VALUE ENGINEERING MOD 1 TRAINING REPORT

SR 10 / Memorial Drive – Sidewalk Improvements
Woodcroft Road to Goldsmith Road
Project No. CSHPP-0007-00(131)
DeKalb County
PI No. 0007131
February 18, 2009

Georgia Department of Transportation
600 West Peachtree Street
Atlanta, GA 30308
(404.631.1770)

MACTEC Engineering and Consulting, Inc.
3200 Town Point Drive NW, Suite 100
Kennesaw, GA 30144
(770.421.3400)

Original:

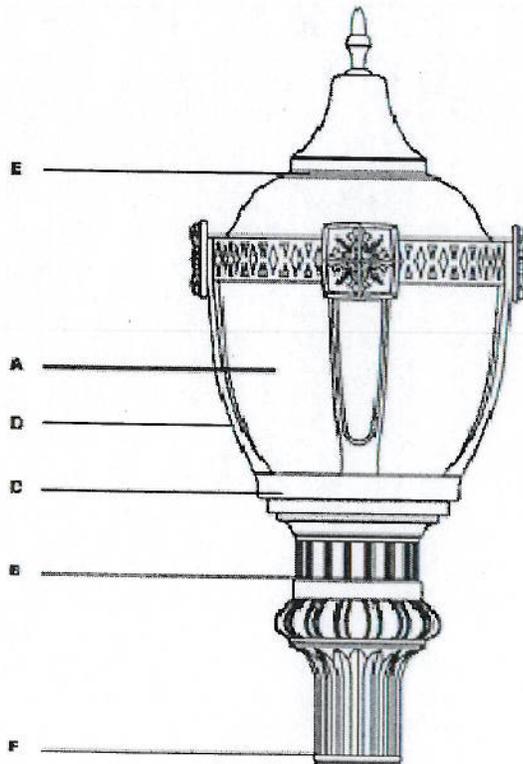
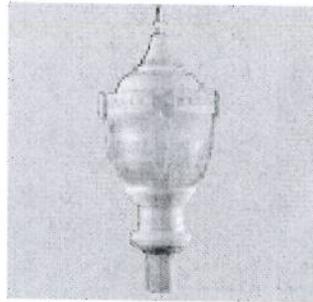
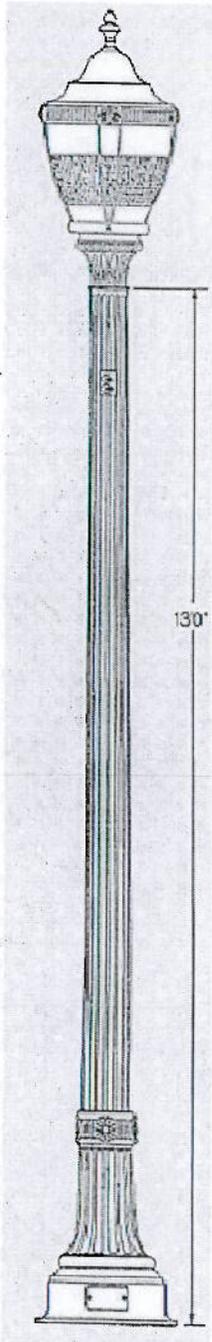
DEVELOPMENT AND RECOMMENDATION PHASE			
Project: Memorial Drive Streetscape CSHPP-0007-00(131) PI No. 0007131			
Idea No.: 1-B	Sheet No.: 1 of	CREATIVE IDEA: Standard Lighting Luminaire and fixture	
Comp By: Date:		Checked By: Date:	
<p>Original Concept: Place new “special” luminaires and fixtures to for pedestrian lighting.</p> <p>Proposed Change: Place standard luminaries instead of special luminaires.</p> <p>Justification: This would require retaining the existing signals and strain poles and upgrade only the control boxes in order to provide for interconnection of the signal system.</p>			
LIFE CYCLE COST SUMMARY	INITIAL Project Cost	FUTURE Project Cost	TOTAL Present Worth Cost
INITIAL COST: Original	1102500.00		
Proposed	630000.00		
Savings	472,500.00		
FUTURE COST: Savings			
TOTAL PRESENT WORTH SAVINGS			472,500.00

STREETSCAPE PLAN
MEMORIAL DRIVE
STREETSCAPE DETAILS

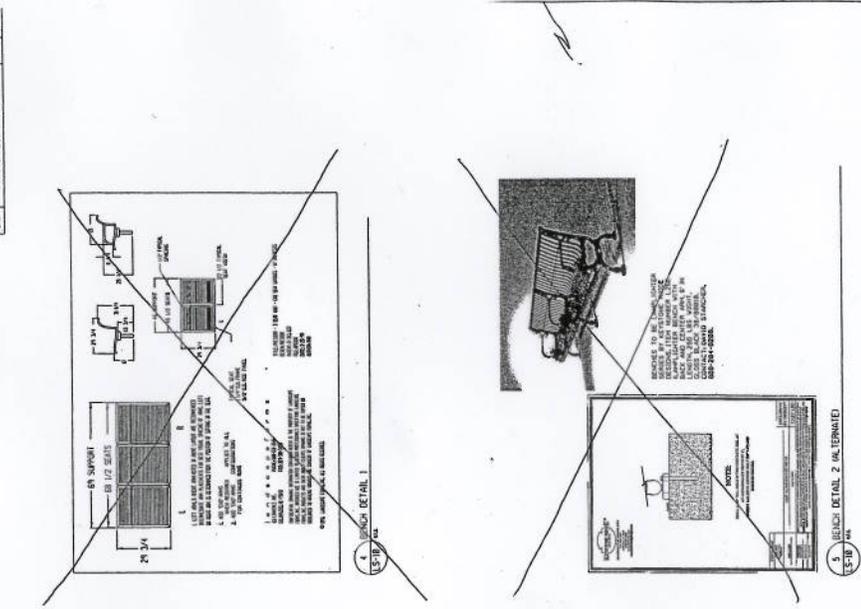
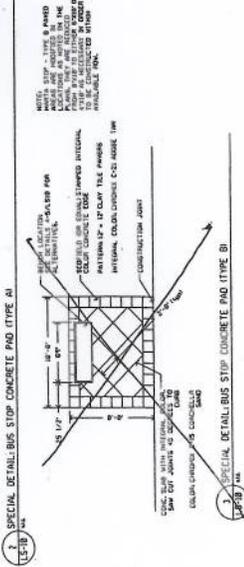
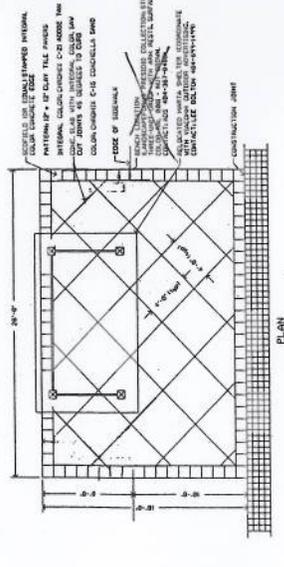
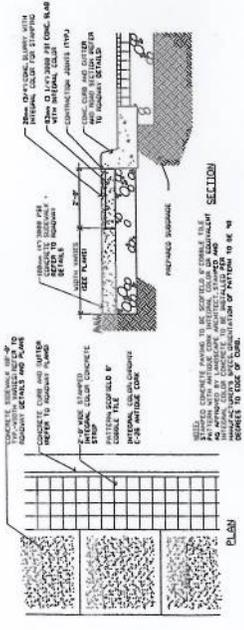
Idea No.: 1-E3	Sheet No.: 1 of 4	CREATIVE IDEA: Remove benches from project
--------------------------	-----------------------------	--

The project included the installation of 24 benches at MARTA bus stops.

Eliminate all 24 benches from the project. Eliminate bus stop pad at locations for benches only. Bus stop pads for Marta shelters would remain but no benches would be included on pad.

The current corridor does not have benches at the bus stops. The total cost for benches is \$55,200 and the pad for bench only stops is \$7,176. Eliminating benches and concrete pad would eliminate this cost.

Idea No.: 1-E1
Client: :
Sheet of 2 of 4

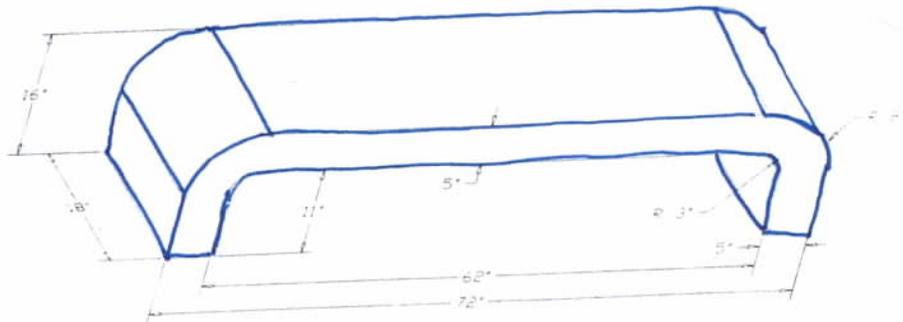
DEVELOPMENT AND RECOMMENDATION PHASE			
Project: CSHPP-0007-00(131) PI 0007131			
Memorial Drive Streetscape Phase 3			
Idea No.: 1-E1	Sheet No.: 1 of 4	CREATIVE IDEA: Use Concrete Benches in lieu of Metal Benches	
Comp By: WNO Date:		Checked By: Date:	
<u>Original Concept:</u>			
Install 24 metal benches at bus stops.			
<u>Proposed Change:</u>			
Install 24 backless concrete benches at bus stops.			
<u>Justification:</u>			
The concrete benches will have a less initial cost. The metal benches are to be bolted to the concrete pad. Concrete benches are placed on top of the concrete pad thus installation costs should be reduced to just putting the bench in place. Concrete color selection to match bus stop pad.			
LIFE CYCLE COST SUMMARY	INITIAL Project Cost	FUTURE Project Cost	TOTAL Present Worth Cost
<u>INITIAL COST:</u> Original	\$55,200		
Proposed	\$17,520		
Savings	\$37,680		
<u>FUTURE COST:</u> Savings		\$0	\$0

Idea No.: 5-A
Client:
Sheet of 2 of 4

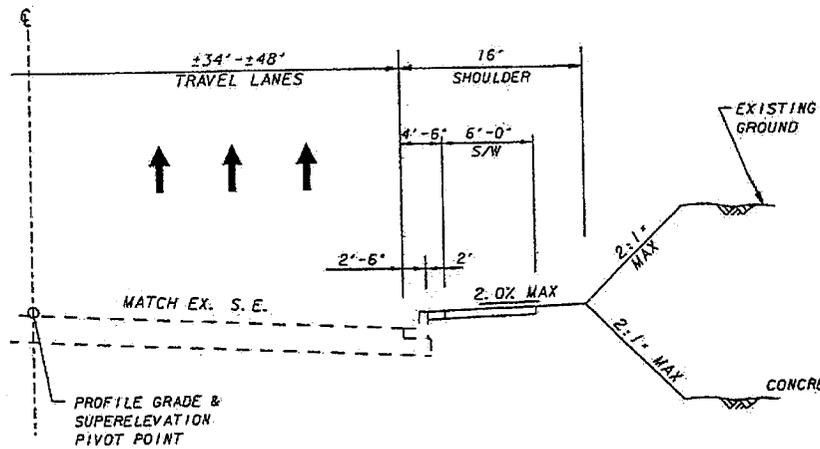
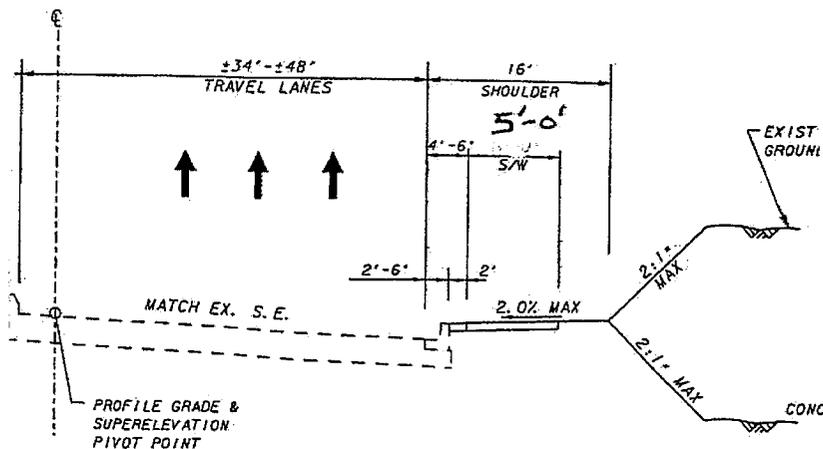
DEVELOPMENT AND RECOMMENDATION PHASE			
Project: CSHPP-0007-00(131) PI 0007131			
Memorial Drive Streetscape Phase 3			
Idea No.: 5-A	Sheet No.: 1 of 4	CREATIVE IDEA: Reduce sidewalk width from 6' to 5'	
Comp By:WNO Date:		Checked By: Date:	
<p><u>Original Concept:</u> The project has 10' sidewalk at the beginning of the project that matches an adjoining project the 10' sidewalk is carried forward for 2040' then changes to 6' wide and 5' wide sidewalk for the remainder of the project, a distance of 48,905'.</p> <p><u>Proposed Change:</u> The VE concept is to maintain the 10' wide sidewalk as in the plans. The engineers had stated there is a future trail project this would tie to. After the 10' wide sidewalk ends the remainder of the sidewalk will all be 5' wide.</p> <p><u>Justification:</u> The 1' reduction will provide reduced cost of the sidewalk and still maintain a comfortable walking width for pedestrians.</p>

Idea No.: 7-A
Client:: GDOT
Sheet 2 of 6

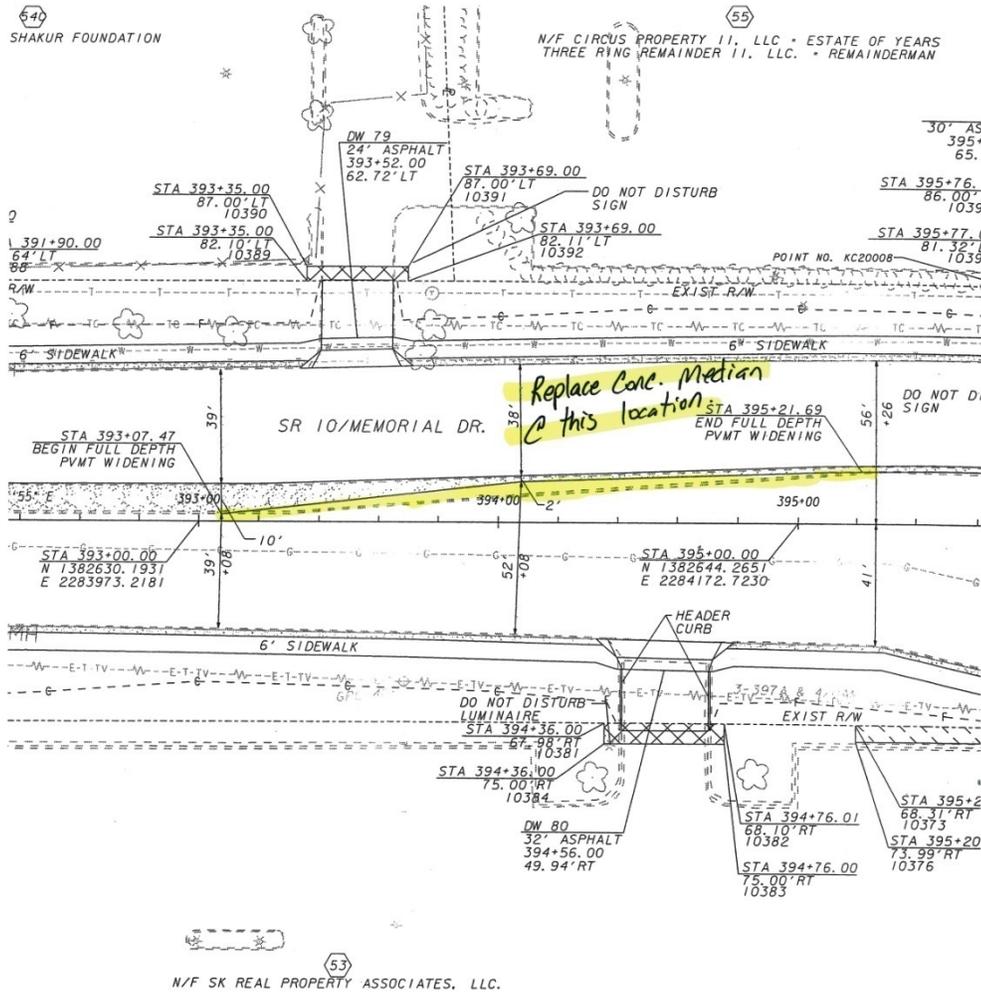
DEVELOPMENT AND RECOMMENDATION PHASE			
Project: CSHPP-0007-00(131)			
Idea No.: 7-A	Sheet No.: of	CREATIVE IDEA: Retain existing Concrete Median	
Comp By: DAN		Date: 1/29/09	
		Checked By: Date:	
<p><u>Original Concept:</u> Replace all existing raised concrete median w/ stamped colored concrete.</p> <p><u>Proposed Change:</u> Only replace the existing median in locations where left-turn lanes are being extended and replace w/ standard concrete median.</p> <p><u>Justification:</u> Existing raised concrete median appears to be in good condition & does not require replacement.</p>			
LIFE CYCLE COST SUMMARY	INITIAL Project Cost	FUTURE Project Cost	TOTAL Present Worth Cost
<u>INITIAL COST:</u> Original	\$2,561,200		
Proposed	\$1,296,401		
Savings	\$1,264,799		
<u>FUTURE COST:</u> Savings			
TOTAL PRESENT WORTH SAVINGS			\$1,264,799
